FINAL DRAFT MINUTES

December 18, 2014 Standards Committee Meeting

RE: Minutes from the December 18, 2014 Standards Committee Meeting

402-NVUF-02 HMA NONMOTORIZED-VEHICLE-USE FACILITY PAVEMENT SECTION ON ABANDONED-RAILROAD CORRIDOR (WITH MARKUPS)

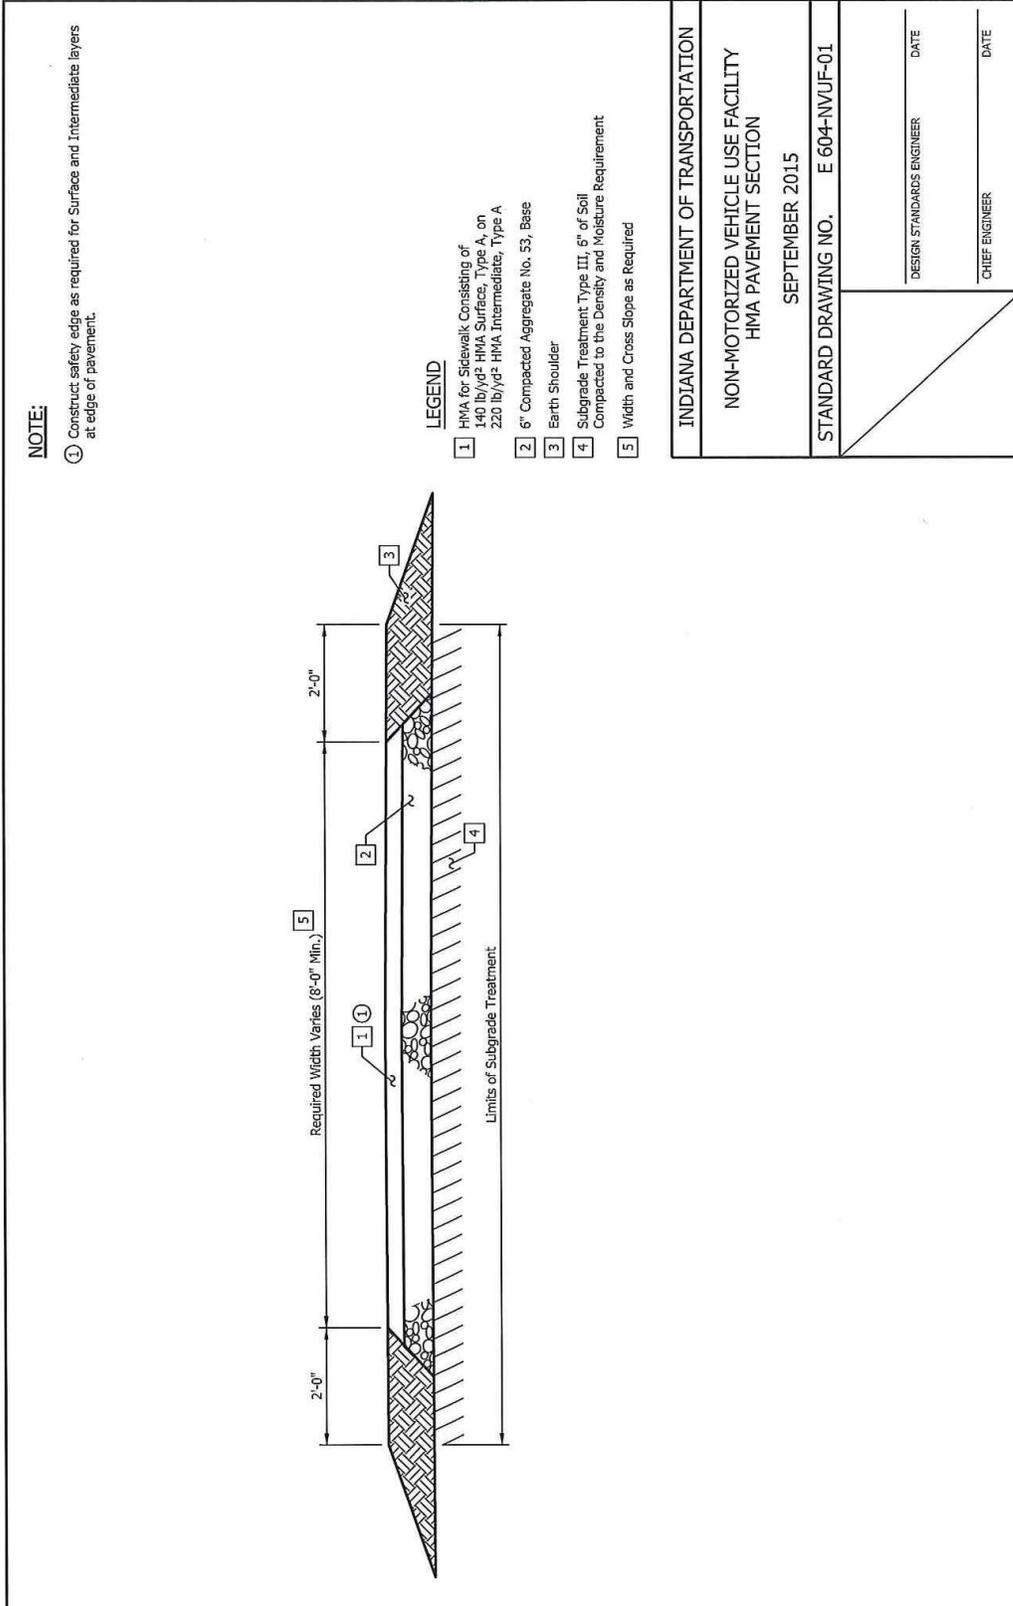
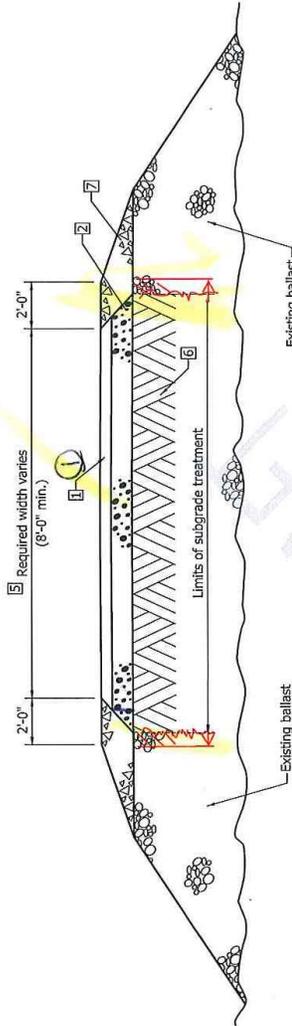
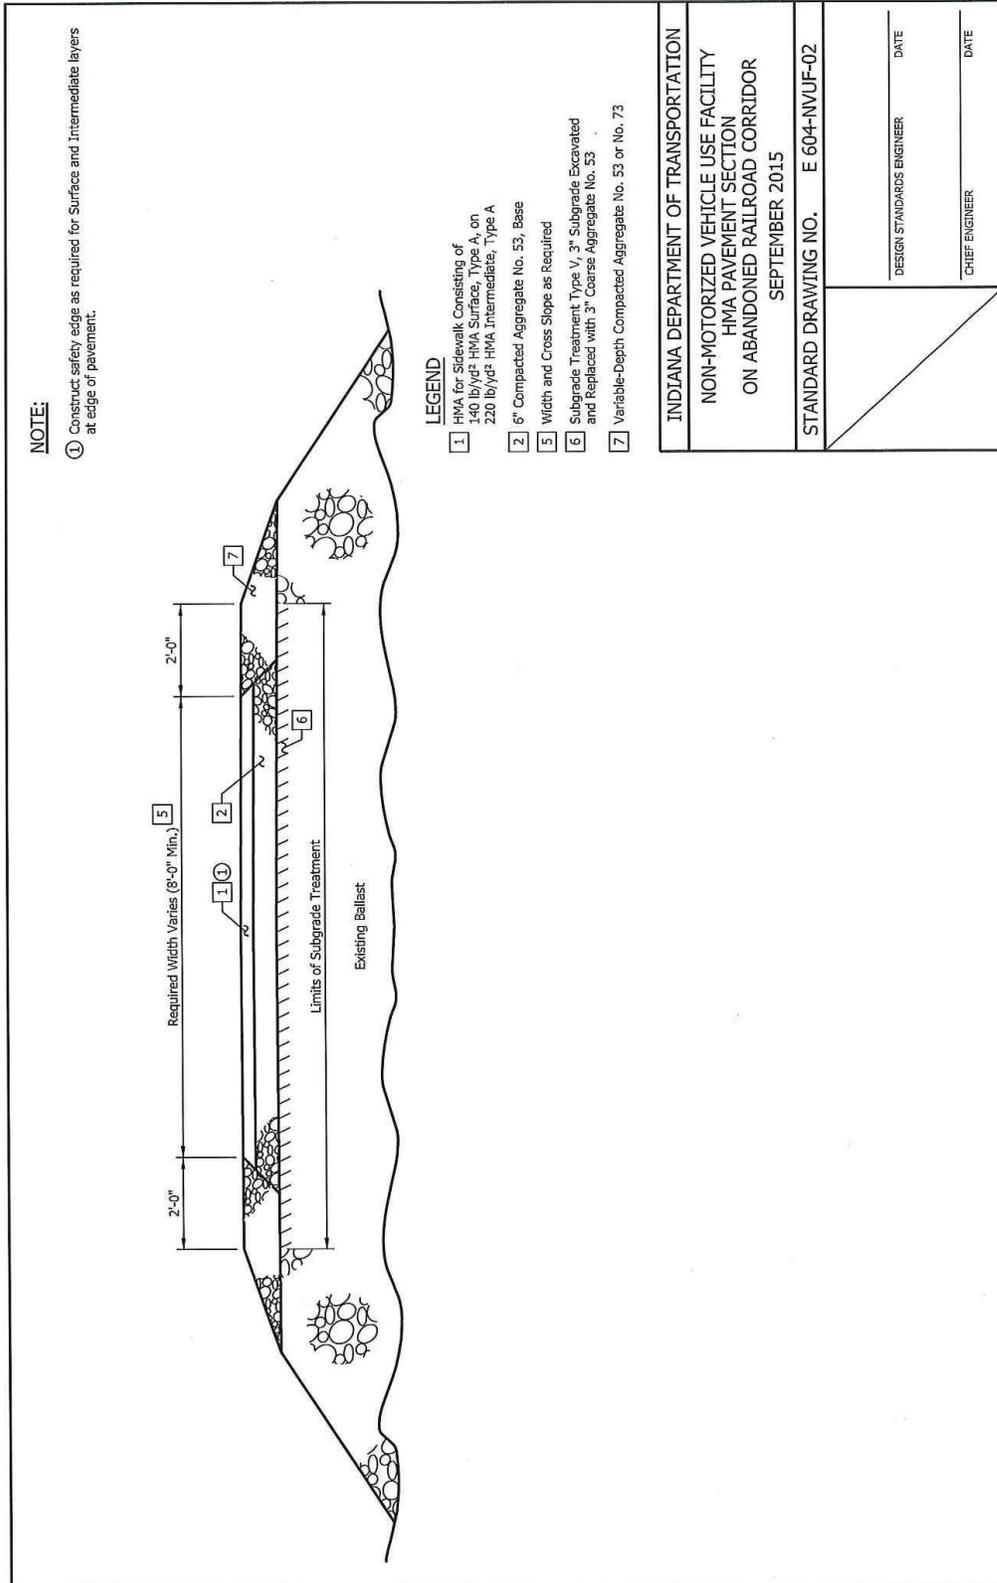
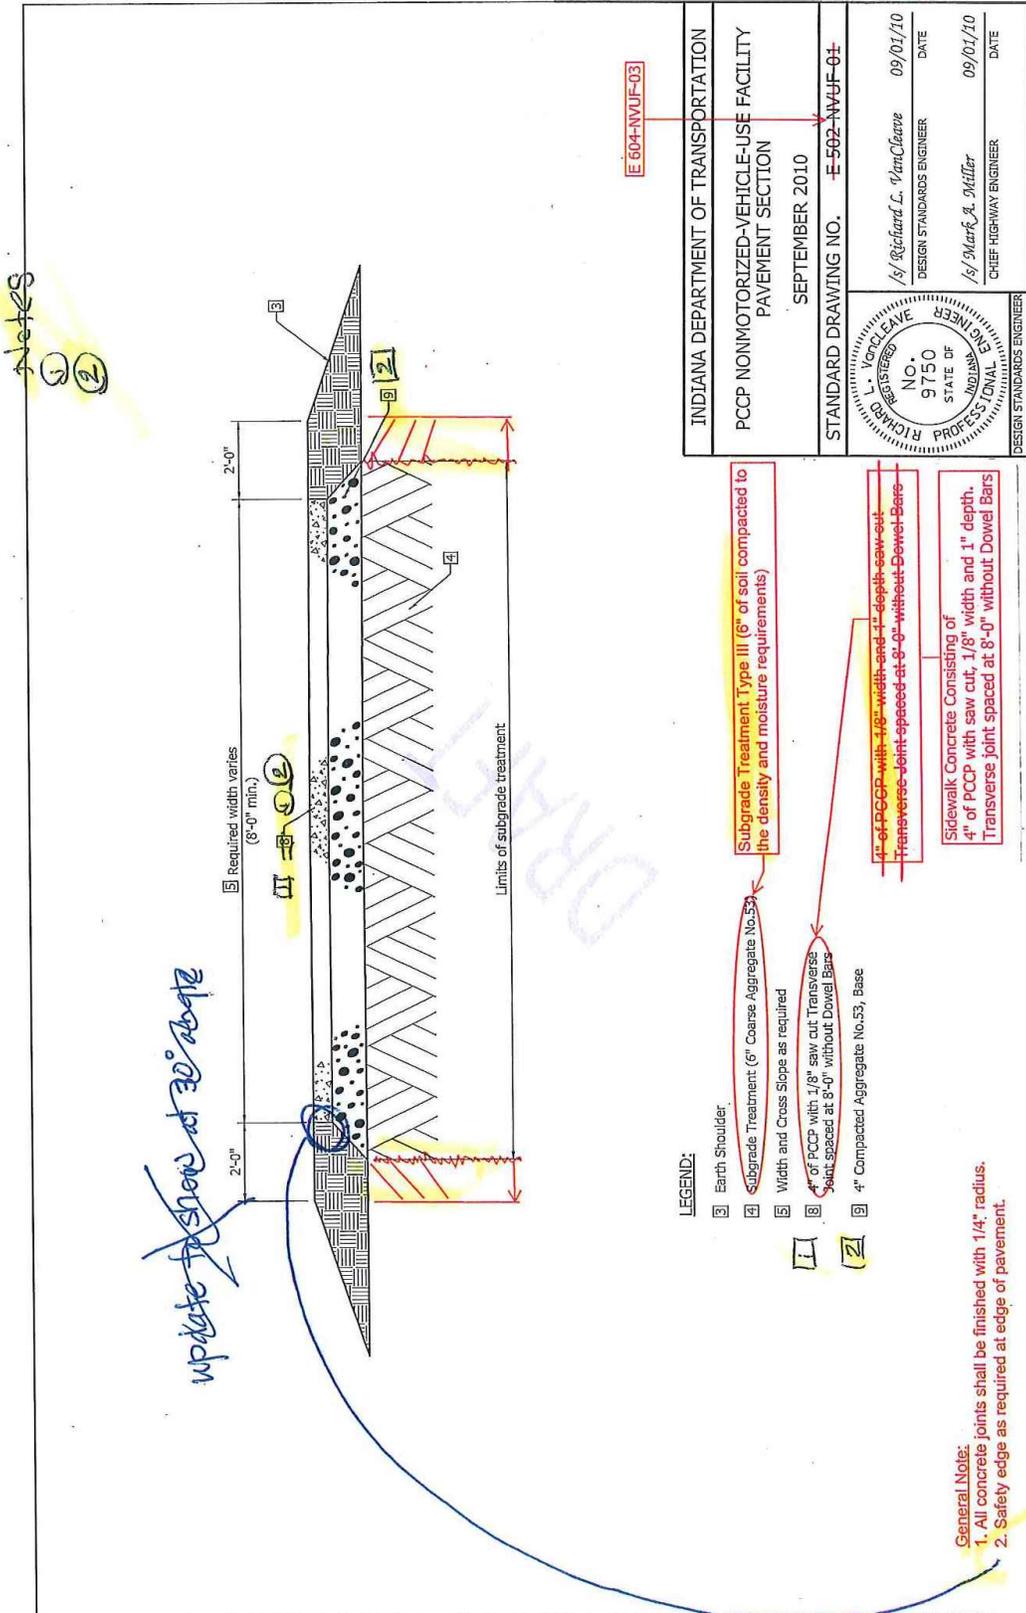
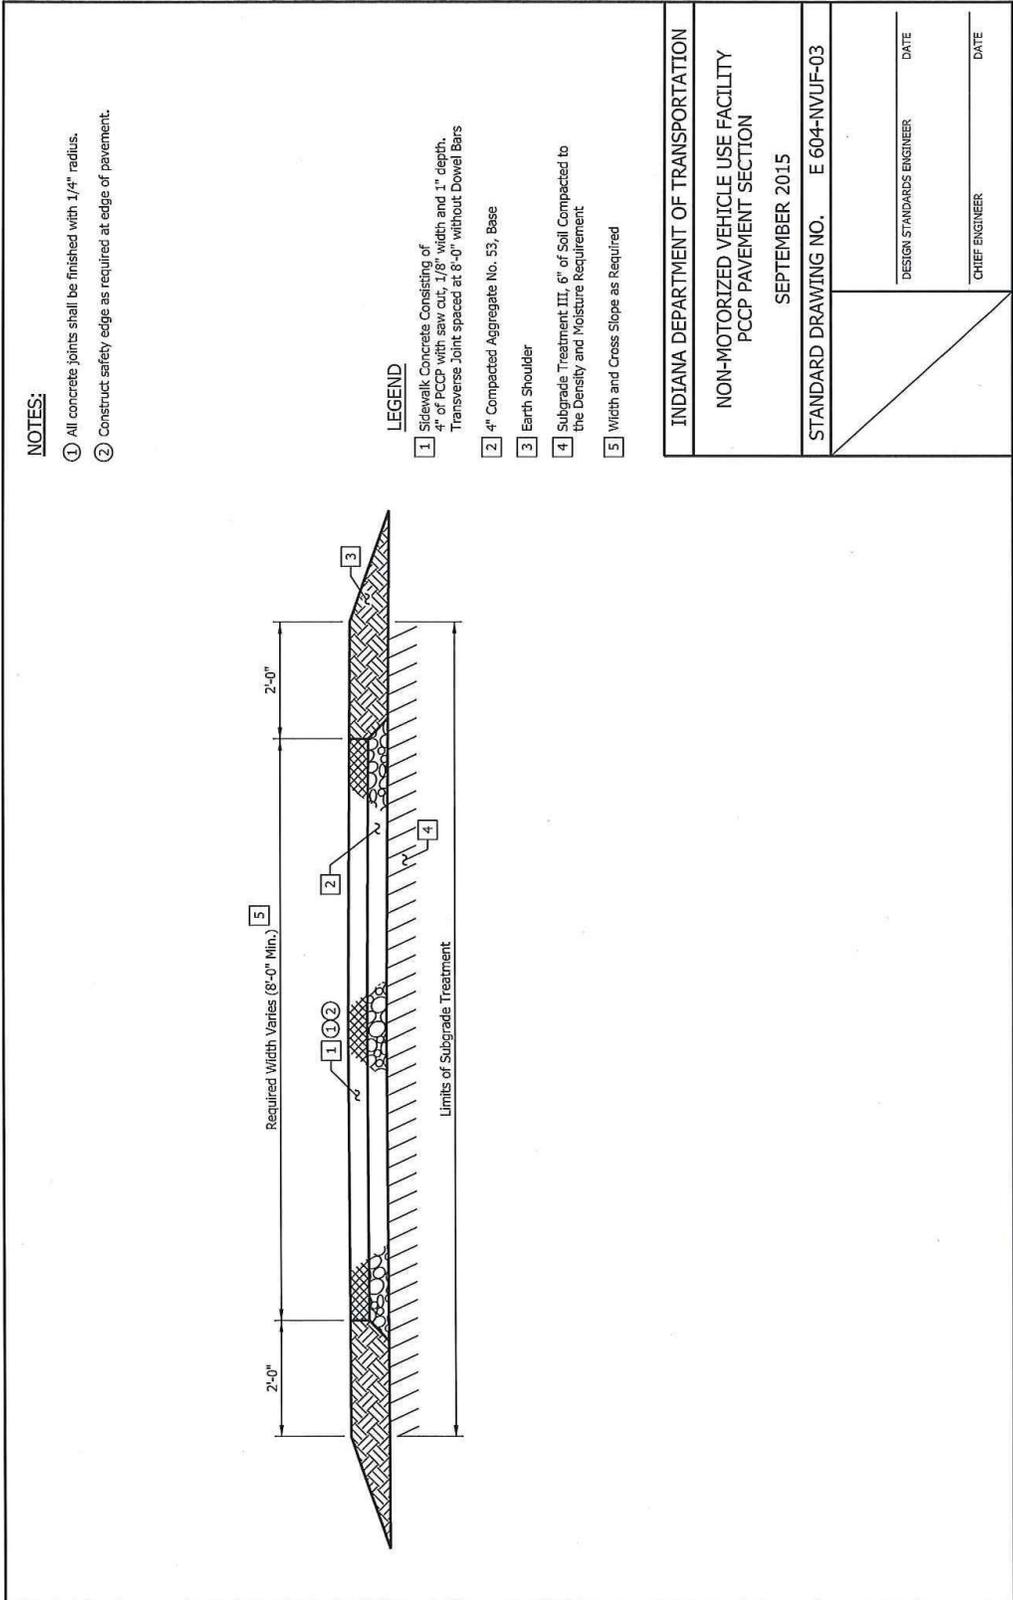
PROPOSED SOLUTION: Revise the E 402-NVUF series to be paid for as HMA for Sidewalk and the E 502-NVUF Concrete to be paid for as Sidewalk Concrete. Update 3-digit lead number to 604 to coordinate with appropriate section of the Standard Specifications.

This item was introduced and presented by Ms. Phillips who expressed the need to revise the E 402-NVUF series, and the E 502-NVUF series drawings to 604 in order to coordinate with the appropriate, 604, section of the Standard Specifications.

IDM FIGURE 405-2Y HOOKS AND BENTS (WITH MARKUPS)

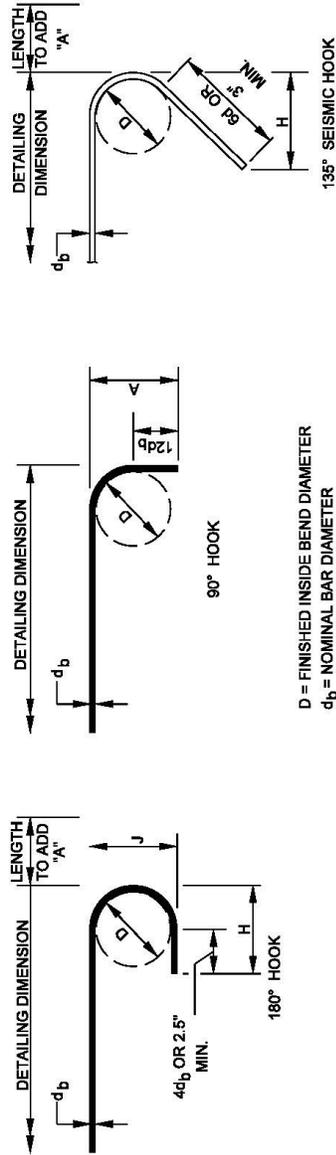
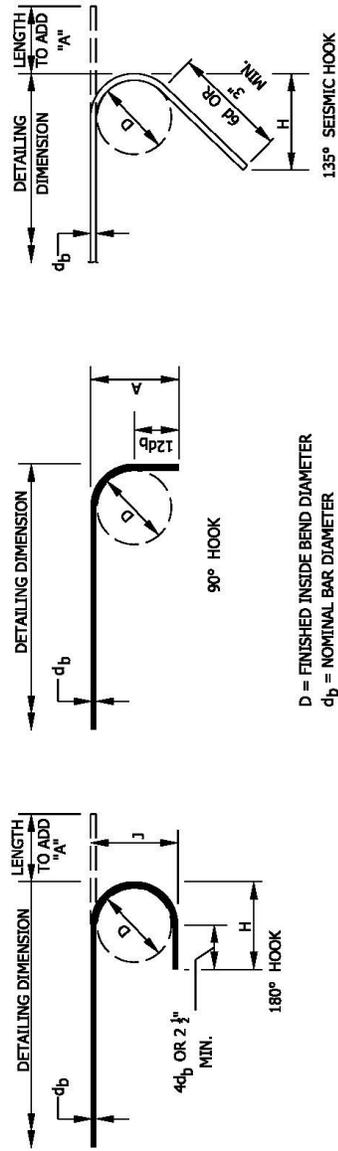
PROBLEM(S) ENCOUNTERED: There are inconsistencies between IDM Figure 405-2Y and Std Dwg E703-BRST-01 regarding the size and dimension for standard reinforcing bar hook details. Neither is completely correct.

PROPOSED SOLUTION: Revise both the Figure and Standard Drawing to be in accordance with ACI 318 and CRSI's Manual of Standard and Practice.

Ms. Phillips introduced and presented this item suggesting that Figure 405-27 of the Indiana Design Manual and Standard Drawing E 703-BRST-01 be revised in accordance with ACI 318 and CRSI's Manual of Standard and Practice.
